49 CFR Part 571

Federal Motor Vehicle Safety Standards; Electric-Powered Vehicles: Electrolyte Spillage and Electrical Shock Protection

ACTION: Final rule.

Figure 7b. S4, S5.3, S5.4.1.3, and S5.4.1.4 Jointed test finger IPXXB

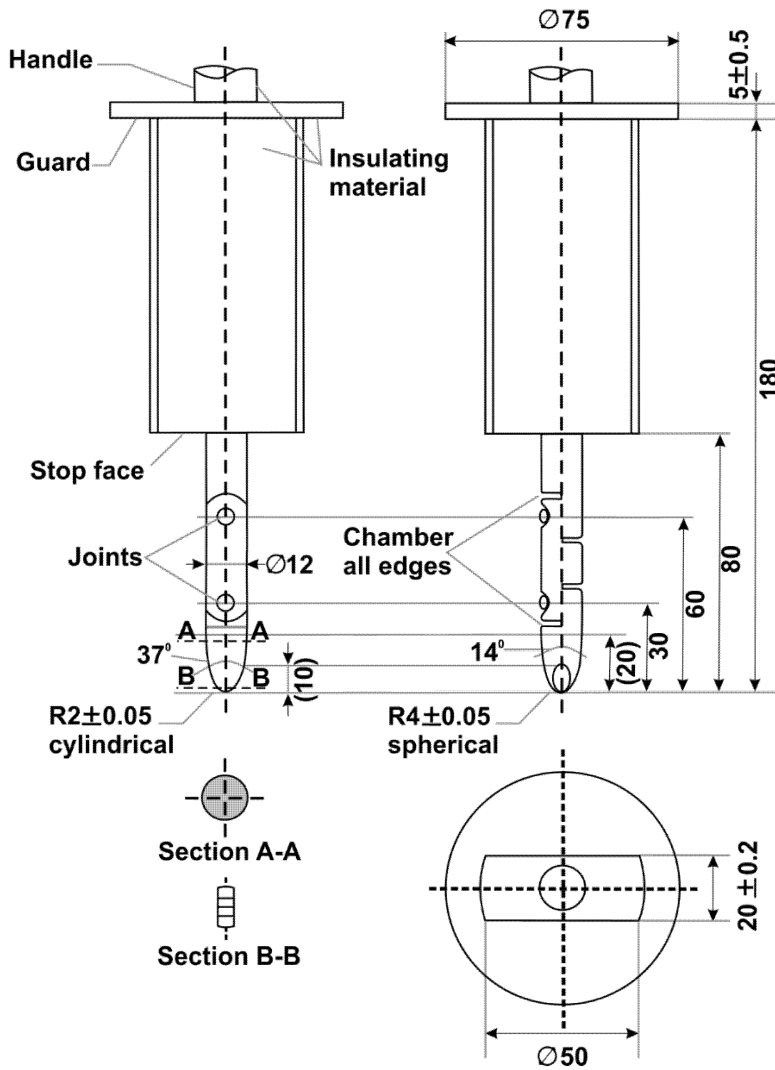
We make a minor correction to Figure 7b and clarify Figure 8.

The proposal provided specifications of the IPXXB probe in Figure 7b of the regulatory text. The Alliance and Global note errors in the specification for R2 and R4. The agency has corrected the errors in Figure 7b.

Figure 8. S9.2 Connection to determine resistance between exposed conductive parts of electrical protection barrier and electrical chassis

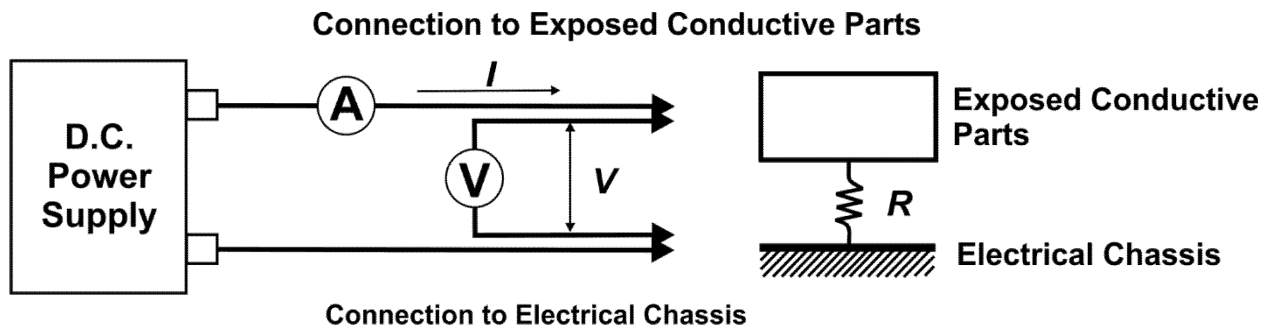
The Alliance and Global provide an improved Figure 8 in which the text is clearer than the NPRM’s Figure 8. The agency has included the new figure in FMVSS No. 305.
